Origination Form Proposed Revisions to a Standard Plans Index

Originator:	Turley, Joshua	Index Number:	700-020
Date:	4/3/2024	Sheet Number(s):	2
E-mail:	Joshua.Turley@dot.state.fl.us	Index Title:	MULTI-COLUMN GROUND SIGN

AND	DAJL	CONNECTION		DLIAILS	
SIGN		INDEX	SHEET			
				700-020	2 of 3

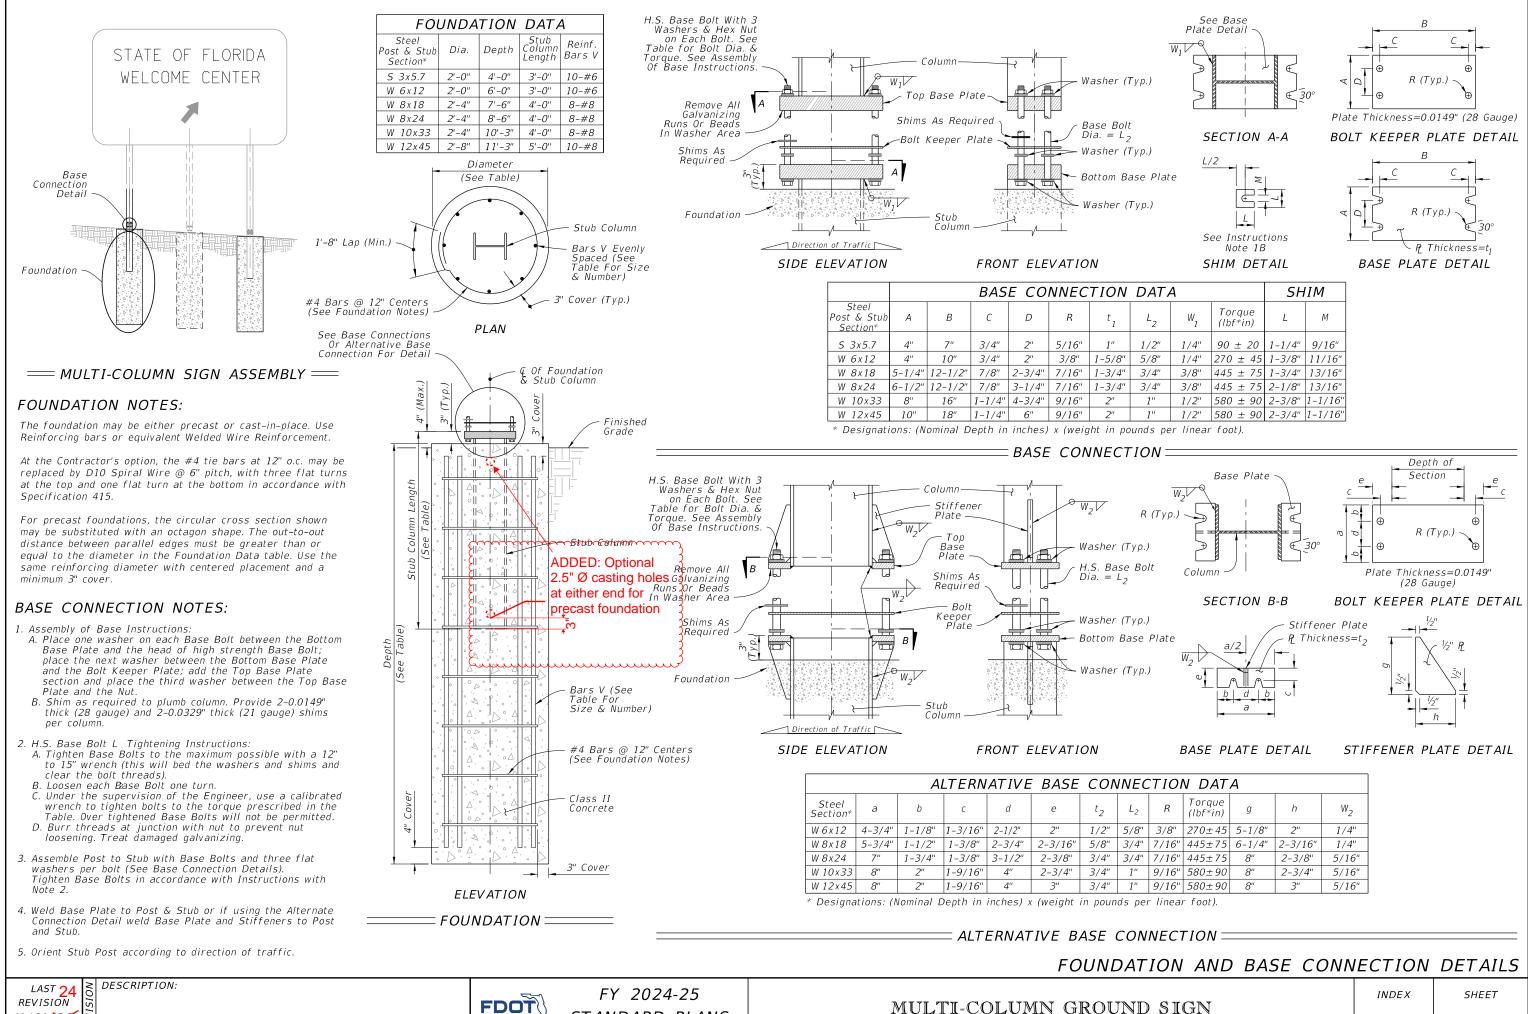
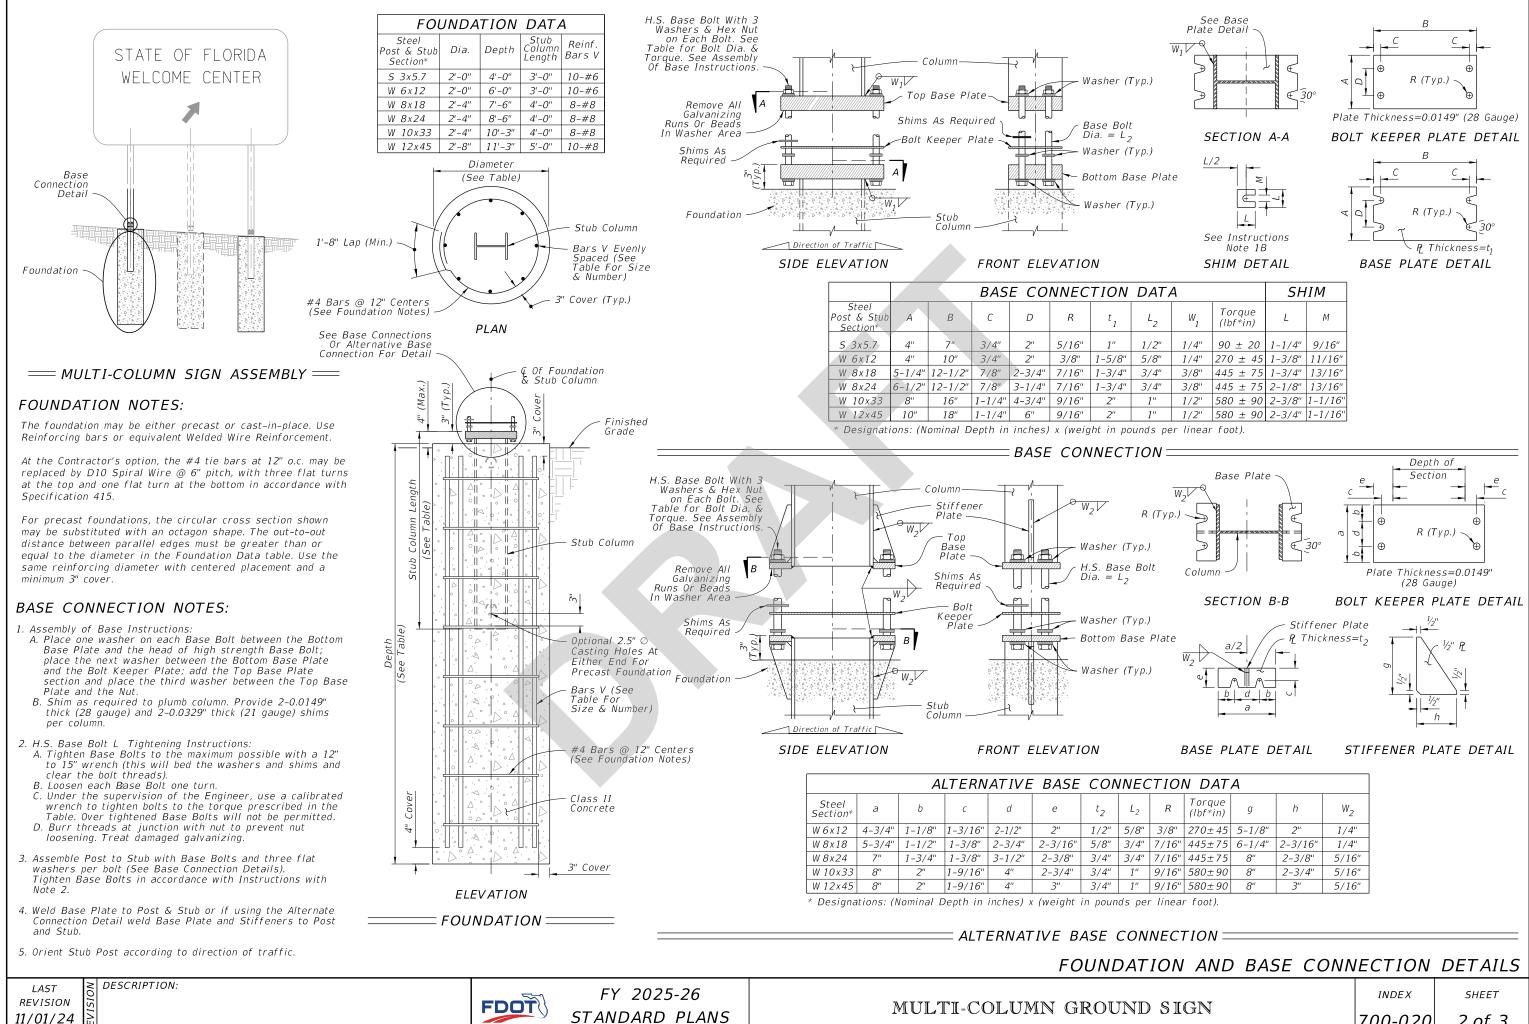
Sheet 2: Adding casting hole option in the stub column to allow for horizontal precast casting. Modifying foundation detail to show the holes.

Precaster requested the casting holes so that they could cast horizontally and not get voids around the embed caused by trapped pockets of air. The holes allow the air bubbles to escape during vibration.
